Development Review Team Memo

(Applicant Response in red – Dated 8/5/2025)

RE: PL20250063 Basecamp Phase II 1850 Luna Ln
Development Plan, Conditional Use and Major Variance
Planning Review Submittal #1

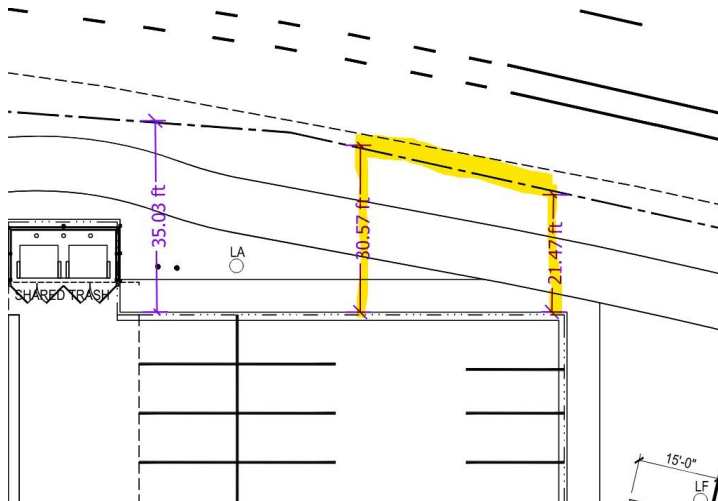
- Reflect a stronger building relationship with Elk River Rd and Lincoln Ave—perhaps by swapping the building and open space/parking locations and including a ground-floor commercial use;

- Enhance and preserve long-term activation and vitality at this key intersection; and
- Ensure the overall site layout supports a functional, integrated, and policy-consistent development pattern.

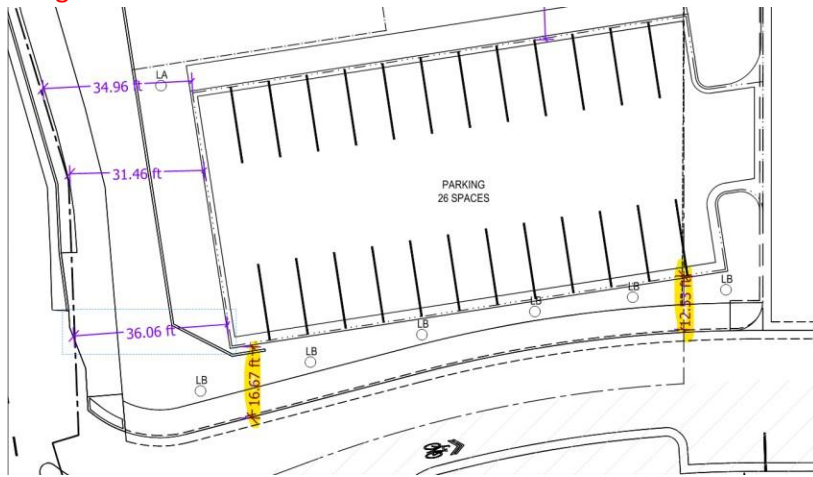
6. It appears a portion of the Lot 2 parking lot encroaches into the required 30' front setback for parking lot placement. Per Section 801.B.1.a.ii, this setback must be measured from the private street easement. Please revise the plan to ensure compliance. **Parking lot has been shifted plan north approx. 8', i.e. as much as possible while still maintaining a viable commercial building footprint area, with adequate pedestrian circulation in front of it, on the subject lot plan north of the parking area. A variance has been included in the Project narrative, as it still does not meet standards with the new design.**

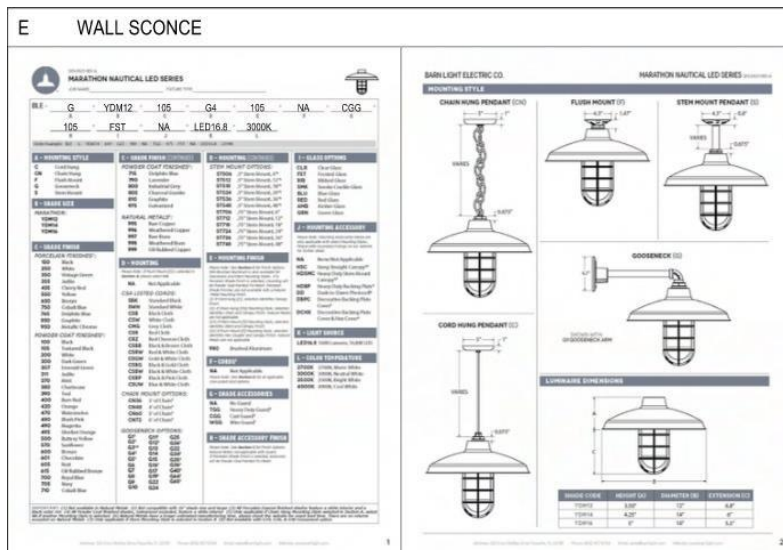
18. The landscape plan incorrectly states that Parking Lot Setback Landscaping is “N/A,” being covered by Frontage Landscaping. Per Section 402.D.2.c and Figure 402-2, when frontage landscaping areas and parking lot setback landscaping areas overlap, the parking lot setback landscaping standards apply. Please revise the plans accordingly to demonstrate compliance with these minimum standards. **Plans have been revised to include parking lot setback areas where they overlap with frontage landscaping.**

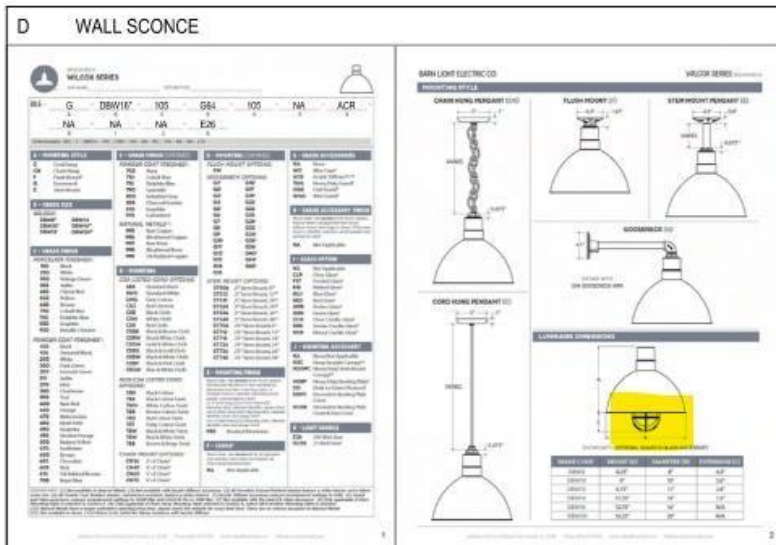
22. The Fixture E Wall Sconce light source is not fully shielded. **Updated wall sconce is now included with full shield.**

23. Fixture D Wall Sconce seems to have an option of light source that is not fully shielded. **Updated wall sconce is now included with full shield.**

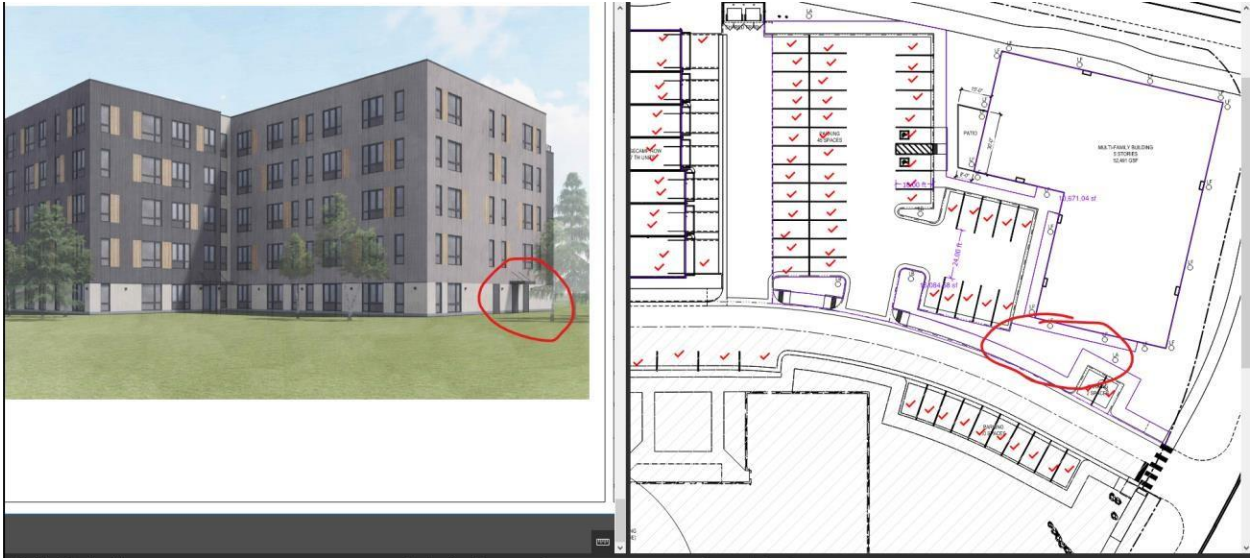
29. The current snow storage approach appears to rely on the development-wide application thread mentioned, which is not explicitly permitted in the CS zone without a variance. To proceed with this approach, the applicant should include a variance request to Section 409.D.1 in the narrative. Section 409.D.3 requires that off-site or shared snow storage be permitted only with an approved snow hauling plan that specifies receiving locations and haul frequency. In the variance narrative, please provide a snow management plan that includes details on long-term maintenance, snow hauling (if applicable), and access arrangements such as easements or plat notes to ensure long-term functionality.

Variance to section 409.D.1 has been included in the narrative and proposes an alternative snow storage location of the detention pond on Lot 1 via a blanket snow storage easement that already exists for the subdivision (Steamboat Basecamp Easements Maintenance and Reimbursement Agreement, recorded at reception no. 861289).

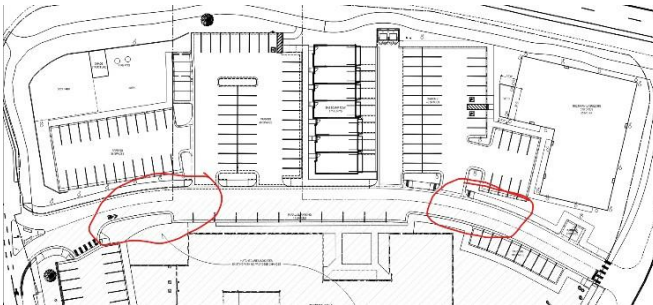
33. What paths are pedestrians expected to take to cross Big Bend Dr?

Two wide striping sections have been added to the site plan in the red-circled areas below. In addition, the applicant also proposes Pedestrian X-ing signage in both directions at both locations. These will reduce out-of-direction travel for pedestrians and help alert drivers of the potential for pedestrian crossings.

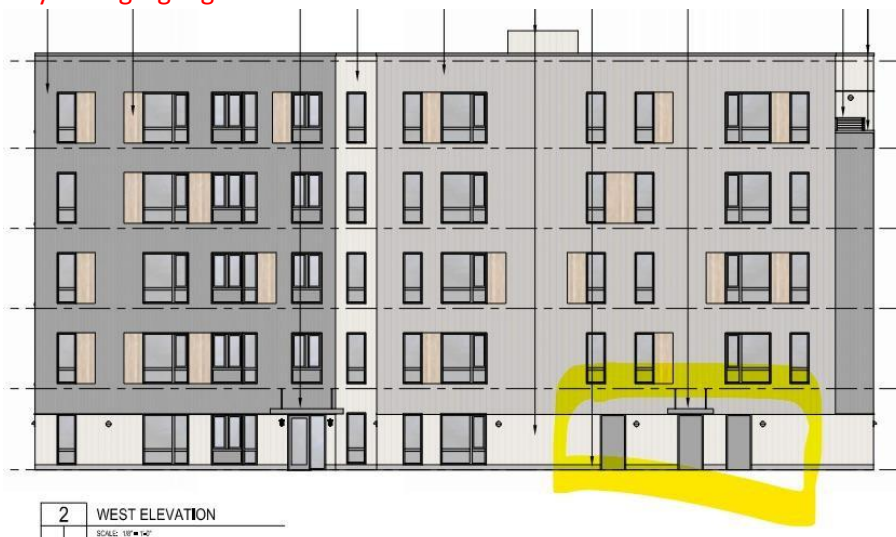
36. The primary entrance on the west elevation appears visually similar to the adjacent utility room door. While the awning provides some distinction, additional architectural emphasis is needed to clearly identify this as a main entry. The entrance highlighted below is actually an egress-only door from the code-required egress stairwell. Access will be controlled at this door, and will only be available for residents, therefore we do not want to call too much attention to it only to confuse the general public. The main entrance is located plan west of this location and includes additional storefront/glazing to make it more pronounced. We plan to include wayfinding signage at this door that directs visitors to the main entrance around the corner.
